Valley of the Winds Wind Farm (SSD-10641)

Response to request for information

April 2024

Project name **Valley of the Winds response to request for additional information**
Project no. **318001172-014**
Recipient **Department of Planning, Housing and Infrastructure**
Document type **Report**
Version **V1.0**
Date **5 April 2024**
Prepared by **Tawna Krause**
Checked by **Belinda Sinclair**
Approved by **Belinda Sinclair**
Description

Figure 3-1 | Road length upgrades

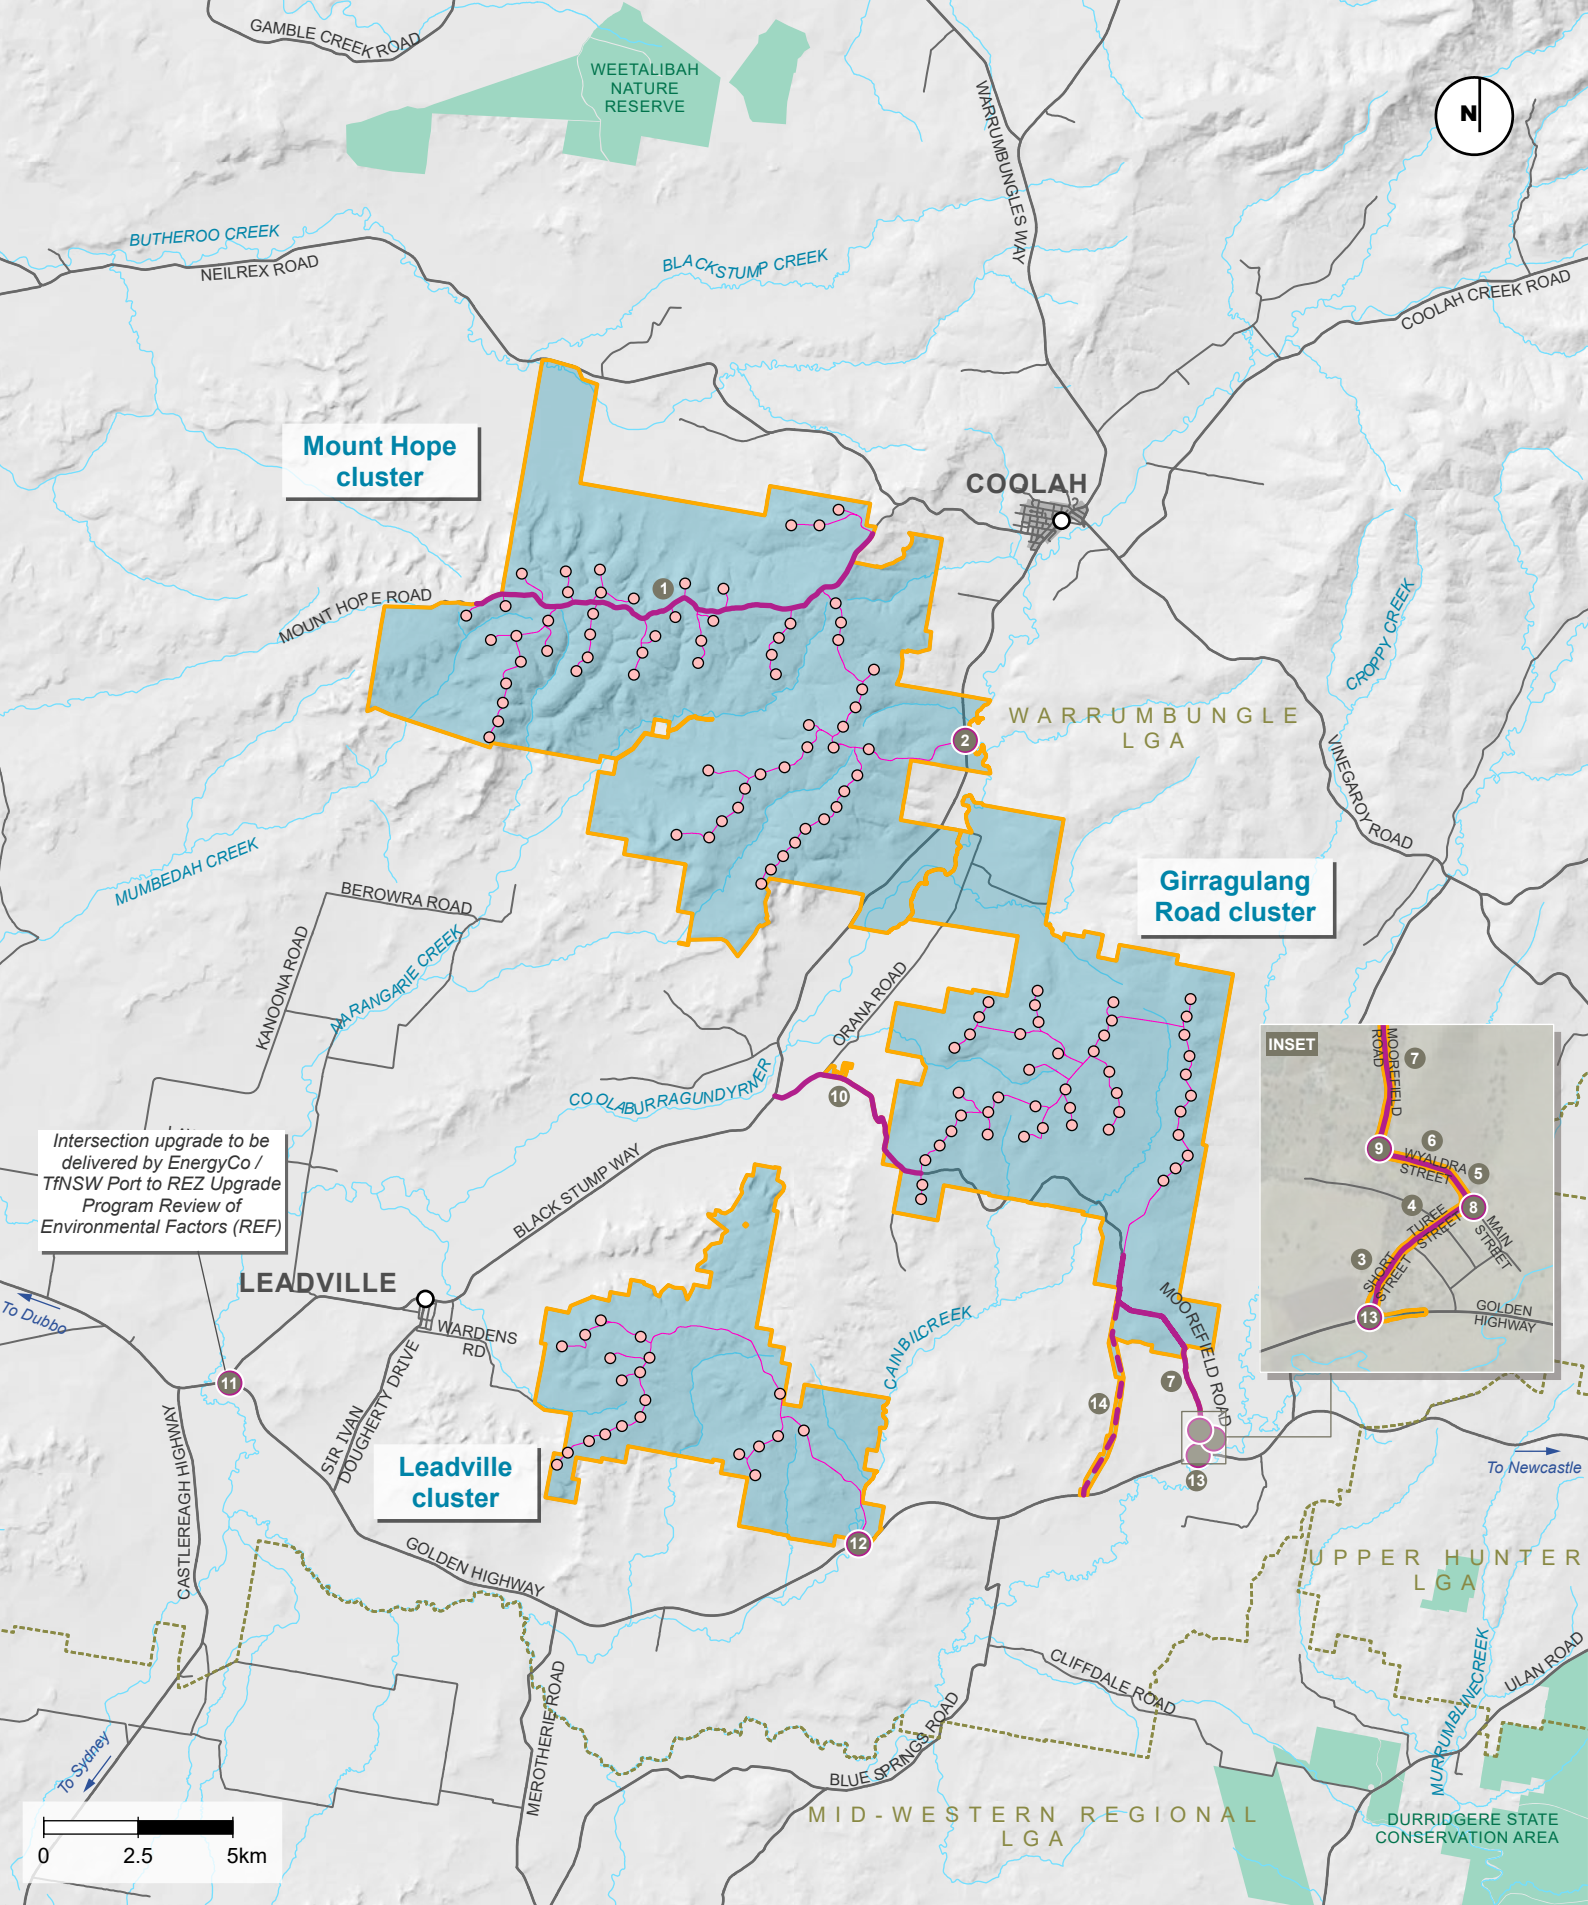
Provide a schedule of road upgrades agreed to with the relevant road authority.

A schedule of road upgrades was prepared as part of the Amendment Report with the current details reproduced in **Table 3-4** below and shown in **Figure 3-1**. Consultation is ongoing with both WSC and TfNSW.
